UNITED STATES
DEPARTMENT OF THE INTERIOR
BUREAU OF LAND MANAGEMENTFORM APPROVED
OMB NO. 1004-0135
Expires: July 31, 2010**SUNDRY NOTICES AND REPORTS ON WELLS**
*Do not use this form for proposals to drill or to re-enter an abandoned well. Use form 3160-3 (APD) for such proposals.*5. Lease Serial No.
NMNM013685

BP America Production Company respectfully requests permission to deepen the subject well. Please see attached procedure, wellbore diagrams and C-102.

CONDITIONS OF APPROVAL TO DEEPEN/SUMP INSTALLATION

Proposed Wellbore Diagram

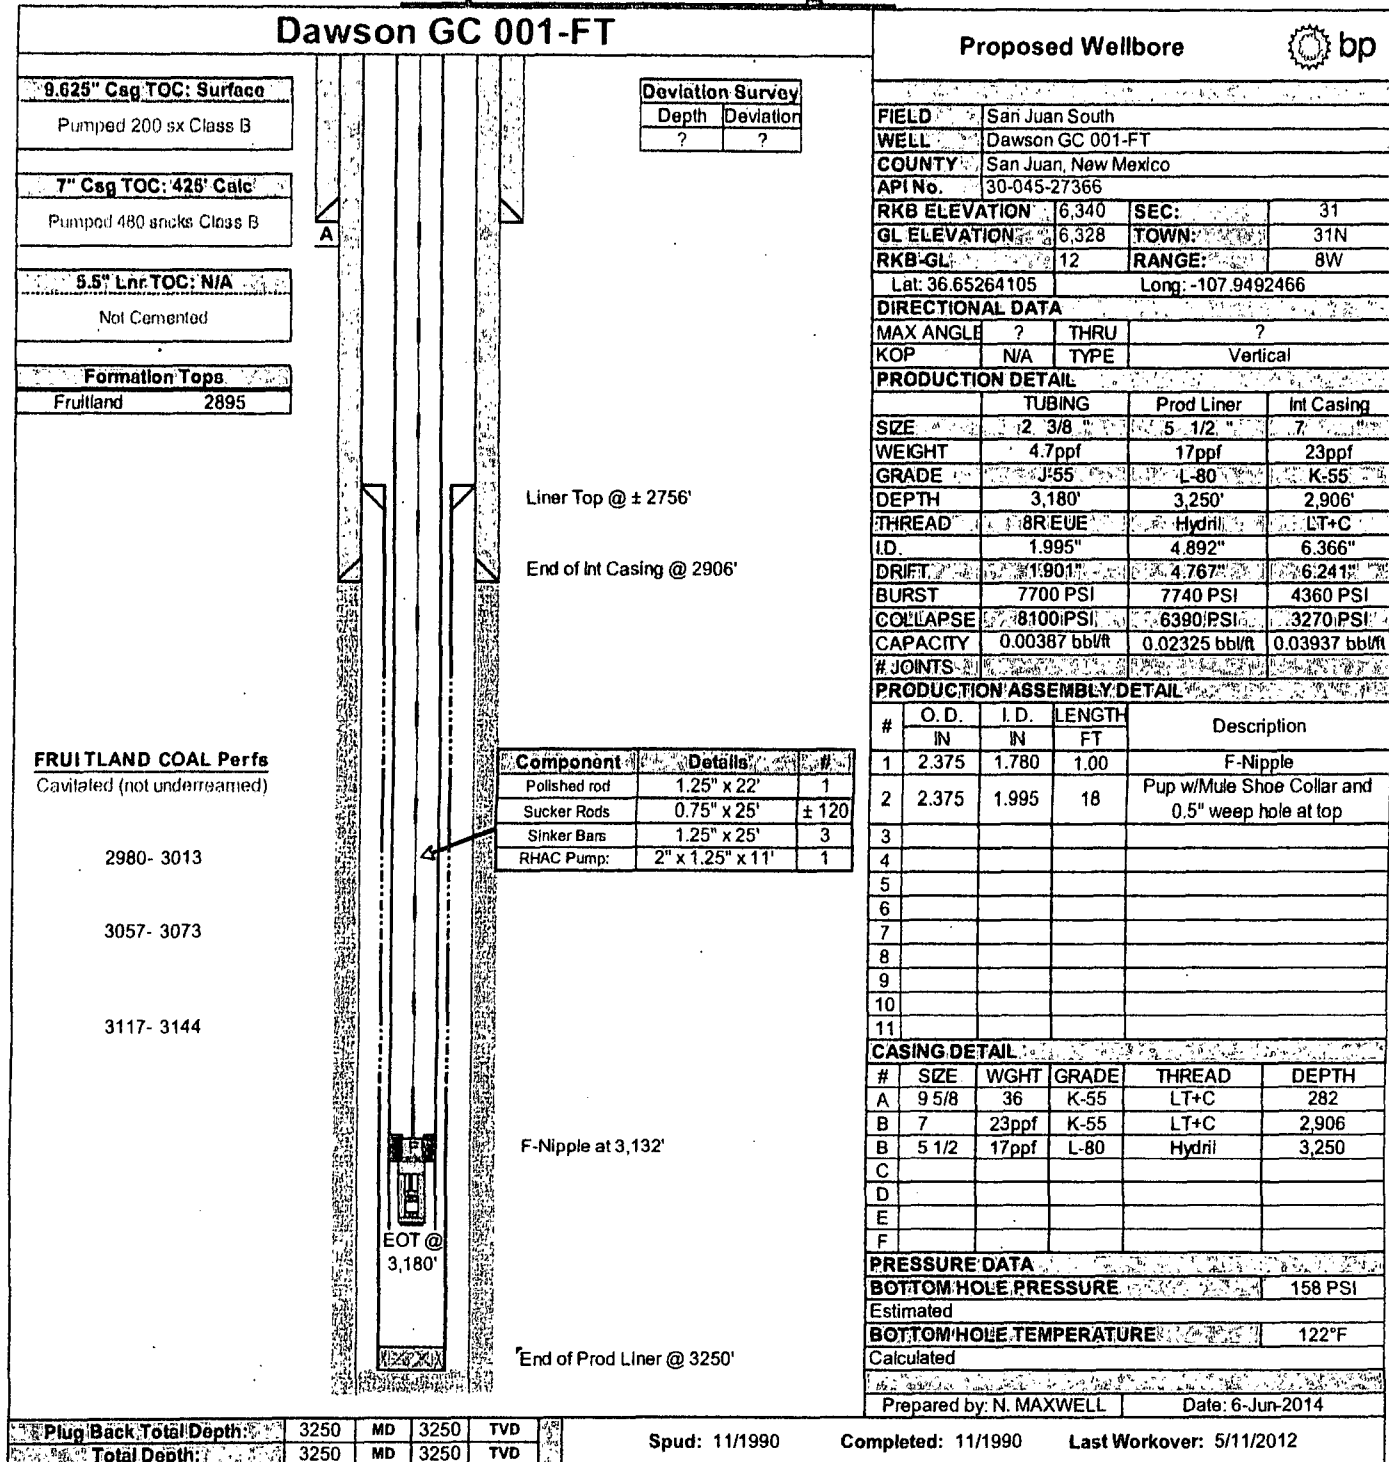
Approval granted to deepen/drill sump as proposed.

Mud logger must be used to monitor total gas and C1-C5 gas components. Contact BLM Geologist Chip Harraden @505-564-7739 and email mud log prior to final completion of this well at : charrade@blm.gov so a final sump determination can be made.
